FREDERICK COUNTY PLANNING COMMISSION

TITLE: Mill Creek Preliminary Subdivision Plan

FILE NUMBER: S-1123, AP#16465, (APFO 16466, FRO 16467, SWM 12908)

REQUEST: **Preliminary Subdivision Plan Approval**
The Applicant is requesting Preliminary Subdivision Plan approval for 143 residential single-family lots on a 65.8-acre site.

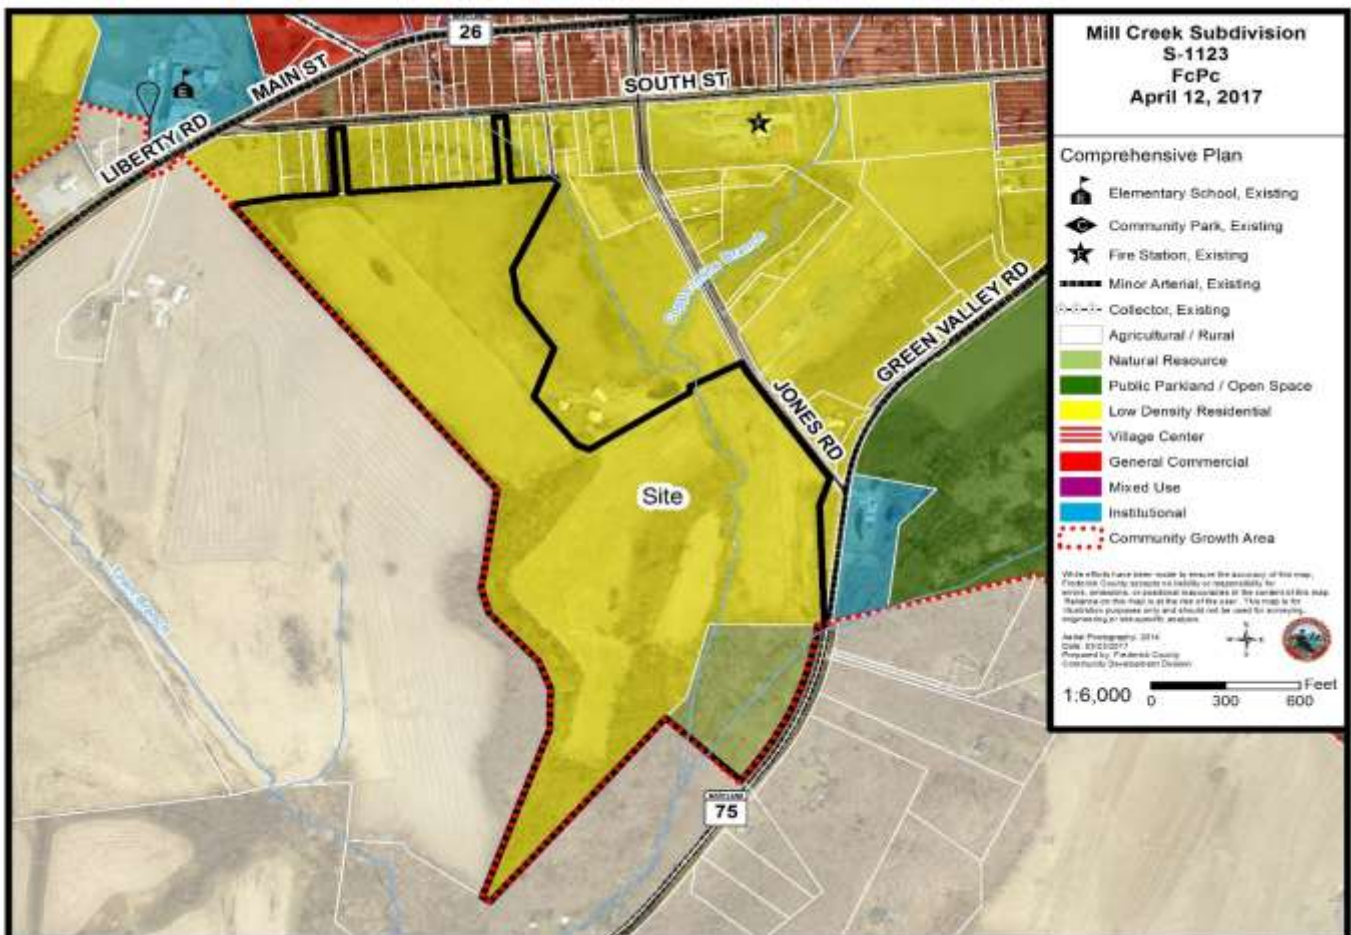
The proposed subdivision design is focused into a northern development area and a southern development area. The stream system and steep, forested slopes act as narrowing elements that dictate the general north/south roadway design, lot placement, and overall site orientation. An entrance from existing South Street provides access to the project from the north. Mill Creek Drive is the main subdivision access from Jones Road and curves north to provide lot frontage and additional roadway linkages and access to lots in the northern portion of the project. Sappington Terrace, one of four (4) cul-de-sacs in the project, and McSherry Way, are the roadways in the southern development area.

The project's design maintains the existing forest cover on the steep slopes within the development site. Floodplain and wetlands buffers are shown, and waterbody buffers were calculated and depicted on the Plan. The Applicant has proposed four (4) areas of waterbody buffer impact (entrance road enlargement, and outfalls for the storm drain, sewer, and stormwater management system components) and has submitted a justification and alternatives analysis as required per § 1-19-19-9.400(D).

The proposed subdivision will contain a series of internal, public roadways with pavement widths of 26 feet. The Plan indicates that on-street vehicular parking will be prohibited in the subdivision, with 'No Parking' signs installed. Staff notes that parking width requirements are nominally 7-8' wide, therefore, no parking is permitted on any 26' road section in order to maintain the minimum 20' two way clearance.

The primary access to the subdivision (Mill Creek Drive) connects to both Jones Road, an existing local roadway, and South Street. Future acceleration and deceleration lanes along Jones Road at the subdivision entrance are shown on the Plan. The current South Street pavement width of 16 feet will be expanded to 20-ft. from MD 26, Liberty Road to the subdivision's new entrance at Mill Creek Drive. The Plan includes widening of Jones road to 20' from the point of intersection with MD 75 to South Street.

Four (4) cul-de-sacs, requiring Planning Commission approval, are proposed in the project with the following lengths and planned number of lots:

- Coale Court (250+/- feet, 10 lots)
- Wagner Court (310+/- feet, 10 lots)
- Riordan Terrace (250+/- feet, 7 lots)
- Sappington Terrace Court (890+/- feet, 26 lots)

All of the proposed cul-de-sacs fall well beneath the recommended threshold of no more than 30 lots and no more than 1,800 feet in length. Two of these cul-de-sacs (Riordan Terrace and Sappington Terrace) are linked to Mill Creek Drive to provide needed connectivity and 'looping' circulation within the subdivision road network. Issues associated with overall property shape, environmental features, and access points are described in the Applicant's justification statement for the inclusion of cul-de-sacs in the project (Exhibit no. 2). A 50-ft wide Open Space Reservation is shown at the end of Coale Court for future, possible access to the adjacent property to the west, which is currently zoned Agricultural and outside of the Libertytown Community Growth Area.

Street, Common Driveway, and Sidewalk Construction. §1-16-109. The Plan includes sidewalks, 5-ft. in width, on both sides of all roads with the exception of 900+/- feet on the north side of Mill Creek Drive, from Jones Road to McSherry Way, and 380+/- feet on the west side of Mill Creek Drive from South Street to Coale Court. As allowed by Section 1-16-30 of the Subdivision Regulations, the Applicant is seeking a modification from the requirement for the construction of complete sidewalks as specified in §1-16-109(A)(3)(b) of the Subdivision Regulations. The Applicant's Modification Request (Exhibit no. 2) describes the site constraints that warrant the sidewalk construction waiver. Thermoplastic crosswalks are described in the road improvement notes on the Preliminary Plan cover sheet and shall be provided at all internal intersections to facilitate safe and efficient pedestrian movement and access in the subdivision.

Closed-section roadways are proposed throughout the project, except for the initial section of Mill Creek Drive from Jones Road to Wagner Court, which traverses the large open space, floodplain, and adjacent residential property on the eastern portion of the site. As allowed by Section 1-16-30 of the Subdivision Regulations, the Applicant is seeking a modification from the requirement for the construction of closed-section roadways as specified in §1-16-109(A)(2) of the Subdivision Regulations. The Applicant provides justification for the use of an open section roadway along a portion of Mill Creek Drive in the Modification Request (Exhibit no. 2), citing the floodplain, wetlands, and stream system as elements dictating roadway design in this particular location.

4. Prior to final signature approval, revise Preliminary Plan note no. 4 on the Cover Sheet to reflect the correct number of on-lot parking spaces provided in the project, by counting ½ of a garage space towards the total number of on-lot parking spaces provided.

5. Prior to final signature approval, revise note 1b. to reference to Zoning Ordinance section (1-19-8.620.5) when describing the MPDU alternative lot standards.

6. Label on the Plan set, the liber/folio for the private landscape buffer easement.
7. The Applicant shall fully execute the obligations within the Mill Creek APFO Letter of Understanding.

8. The Open Space reservation at the terminus of Coale Court shall be owned and maintained by the HOA, but shall not be designated as an Open Space parcel. The reservation area shall be conveyed to the County at the County's request for extension of Coale Court if and when the adjacent property to the west of the Mill Creek subdivision is developed.

10. Planning Commission approval of the requested modification to the requirement, pursuant to 1-16-109 of the Subdivision Regulations, for the construction of complete sidewalks.

11. Planning Commission approval of the requested modification to the requirement, pursuant to 1-16-109(A)(2), for closed section roadway construction.

12. Planning Commission approval of the requested modification to allow a 49.5-ft. right-of-way for a portion (approximately 300 feet) of Mill Creek Drive, a local, public street.
